Contract Description: Main Pumping Station - East Reservoir Addition

CONTRACT CHANGE ORDER NO. 1

OWNER: Village of Orland Park, Illinois
CONTRACTOR: Joseph J. Henderson & Son, Inc.
P.O. Box 9
Gurnee, IL 60031
CONTRACT: East Reservoir Addition

Village of Orland Park, Illinois
East Reservoir Addition

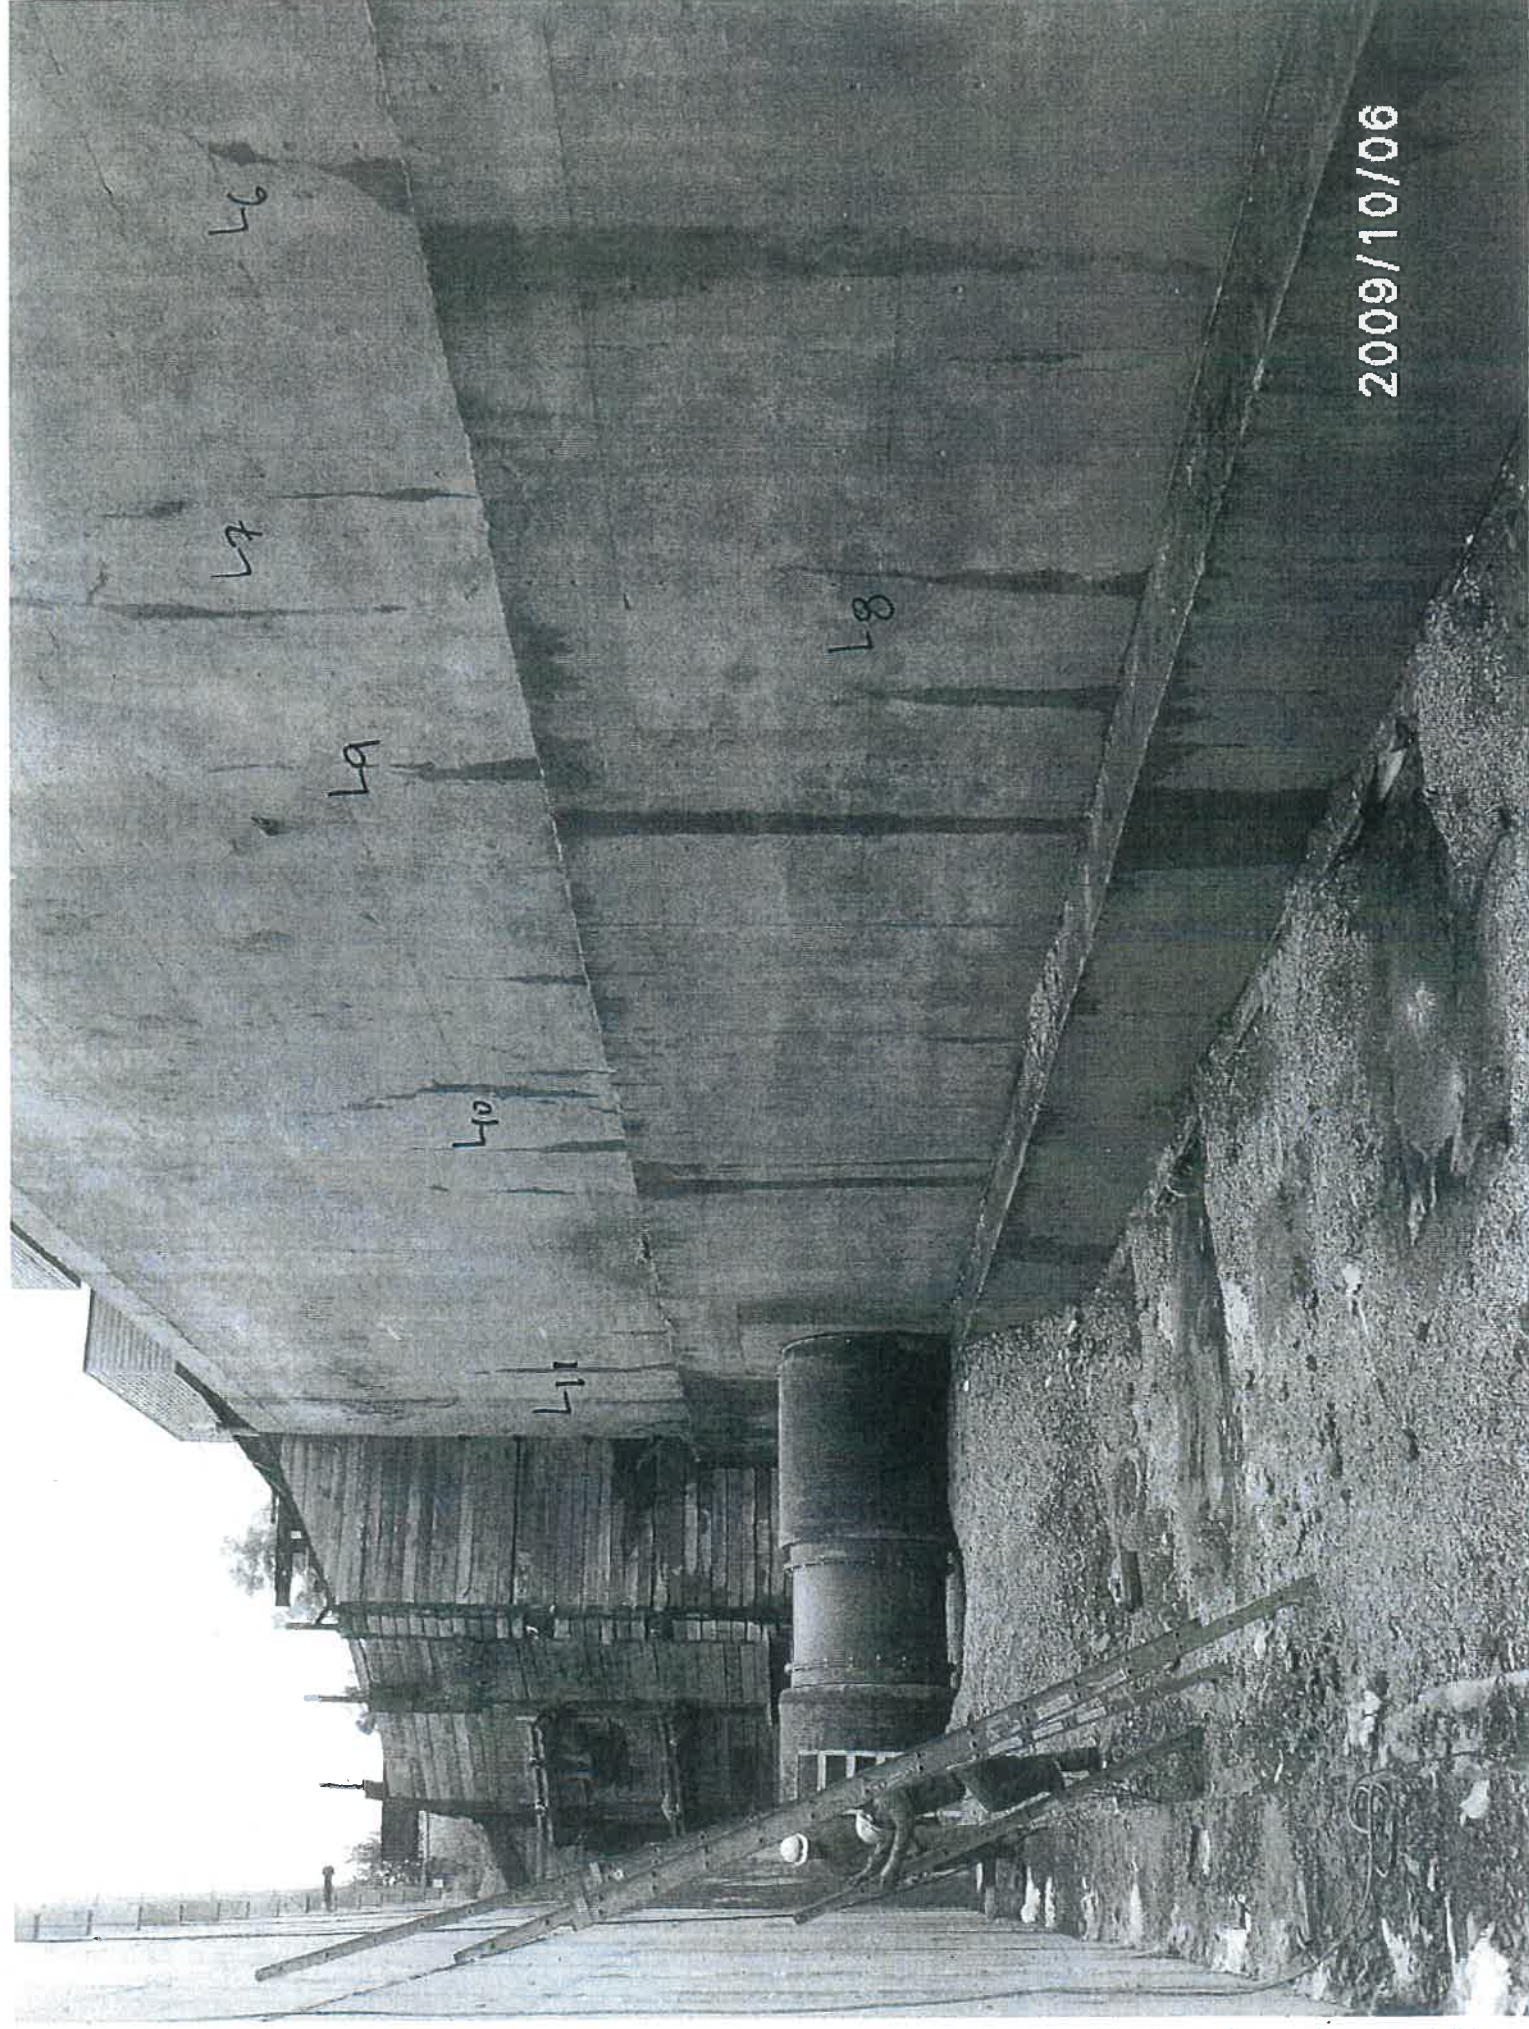
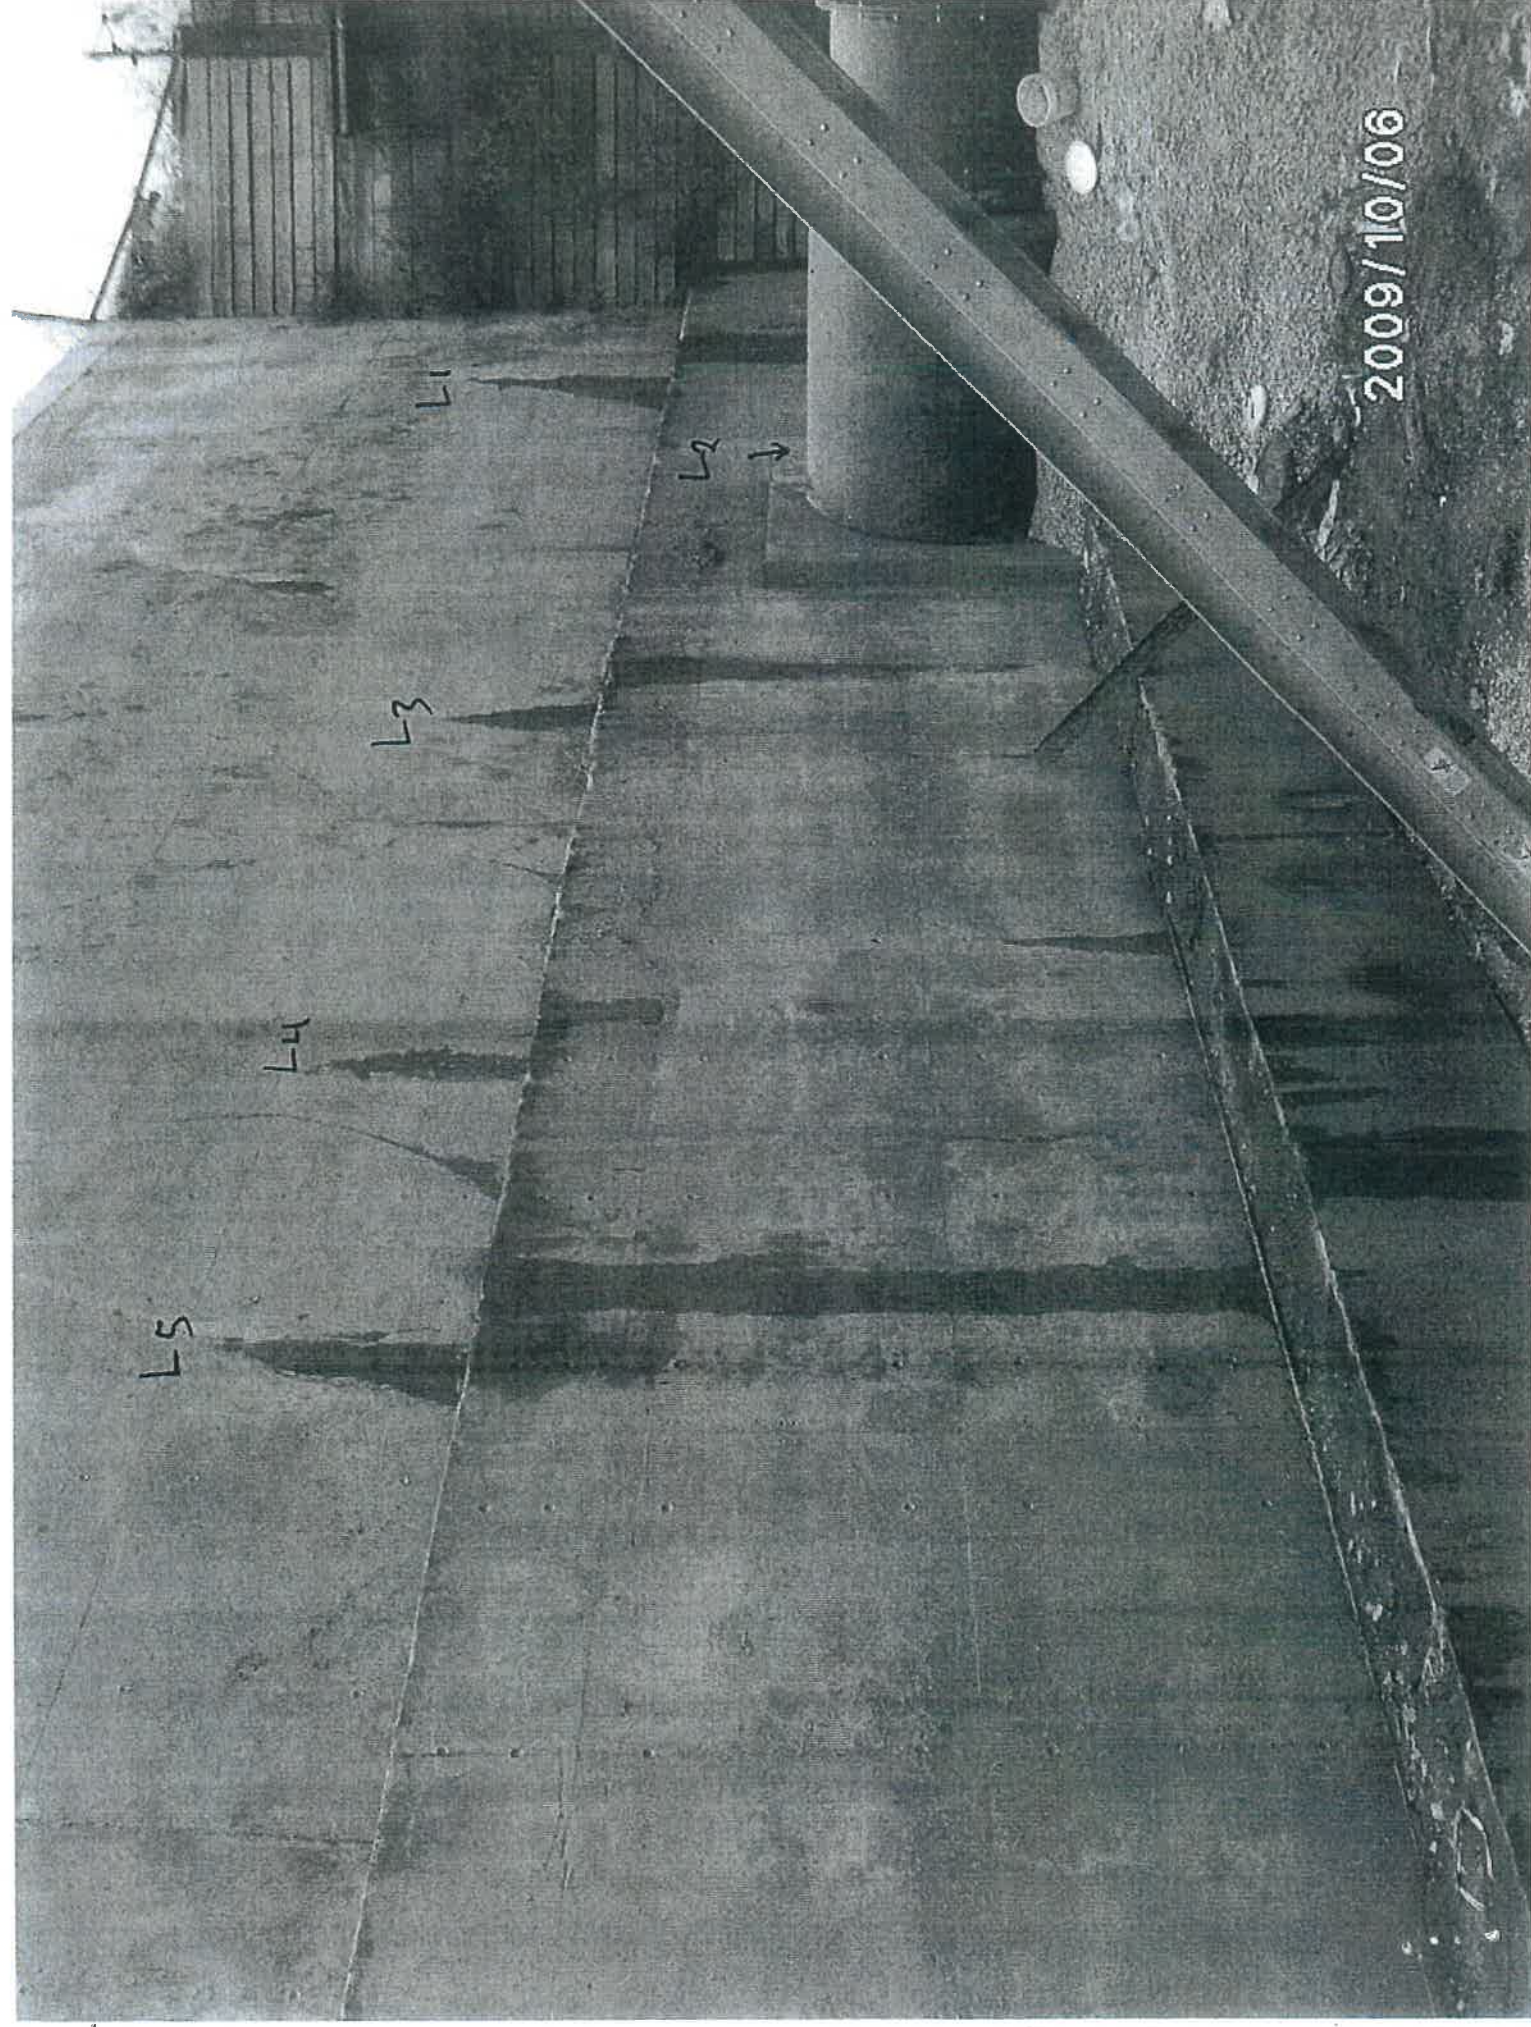
Good morning. As requested I have attached several photos of the leaks in the central reservoir east wall as of today at 11:00 AM. By my count there are approximately 11 locations that are at least damp on the east wall of the central reservoir at this time. Only two of those leaks appeared to be actively weeping, L5 more so than L10 on the attached photos.

Keith has marked the visible leaks on the Central Reservoir wall. It appears that most of these are not very significant. I have attached the labeled photographs that Keith provided. Based on this information, we would like for JH to do the following:

- Monitor the cracks over the next few days with Keith while work continues on leak repairs for the East Reservoir
- Addition
- Provide a change order cost estimate for repair of cracks L5 and L10 for our consideration

Based on information gathered above, we can then determine if the Village should proceed with repair of cracks L5 and L10. Let me know if you have questions on this request.

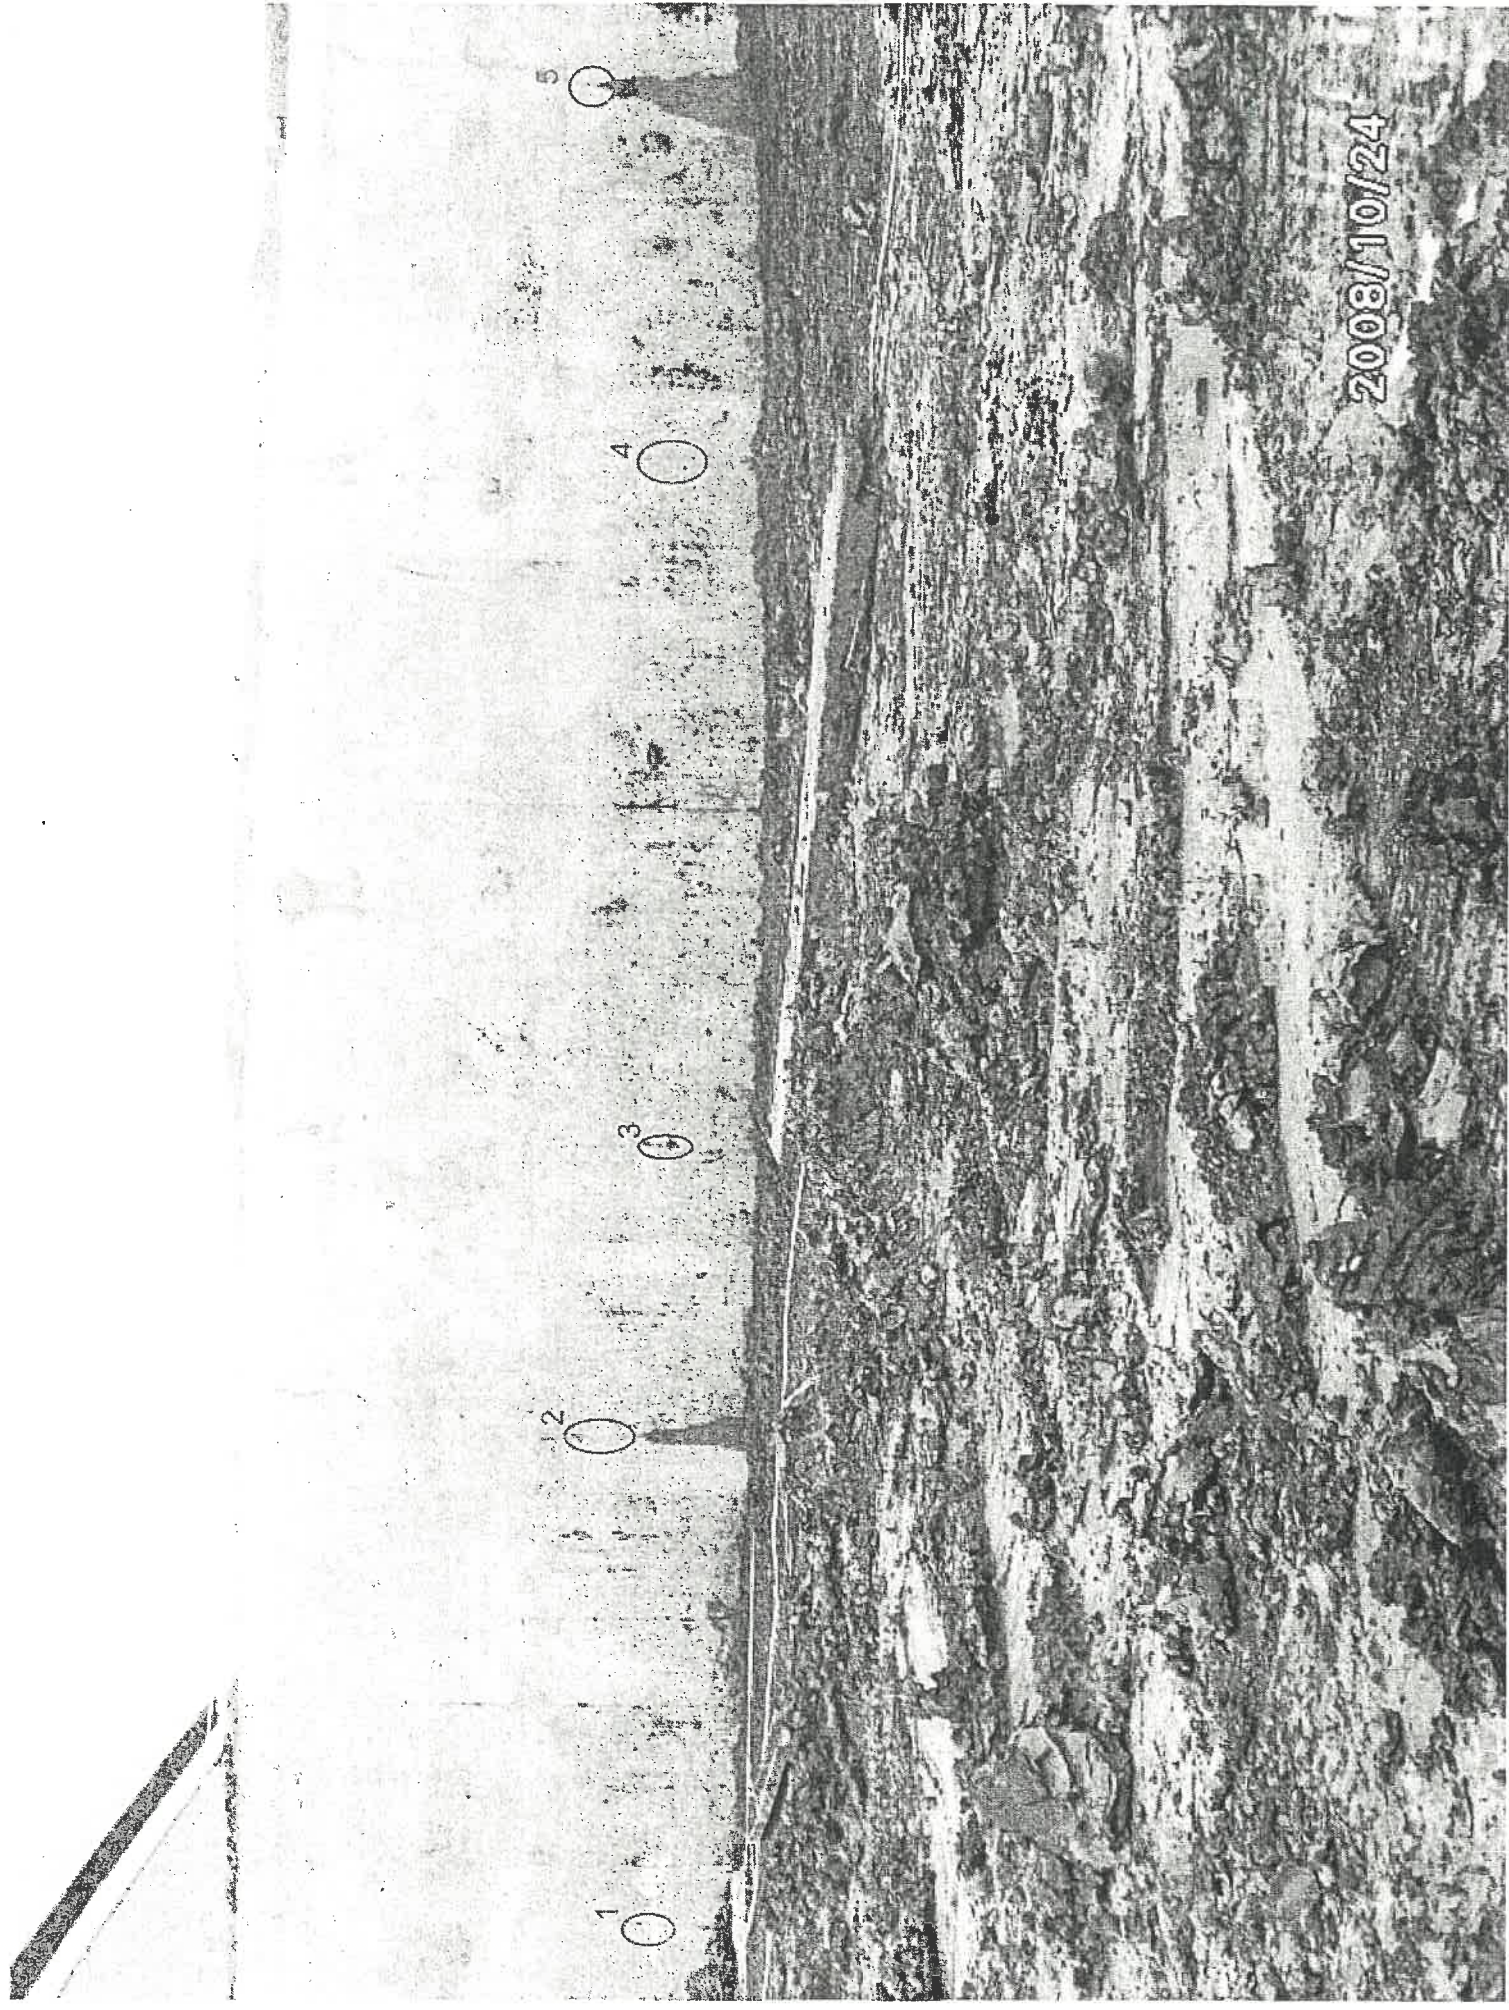
I have attached a few pictures of the east exterior of the existing reservoir as well as pictures of the cracks inside. Below are the rough measurements I took of the location of these cracks with those numbered 1 (most southern) through 5 (most northern) referring to exterior cracks and the lettered locations interior locations. All measurements are taken with respect to the exterior south edge of the reservoir at the current elevation (I added the wall thickness to the interior measurements I took).

1. 21'-10"
2. 40'-7"
3. 51'-8"
4. 78'-5"
5. 93'-5"

- A. 21'-6"
- B. 42'
- C. 54'-3"
- D. 67'-7"
- E. 78'-1"
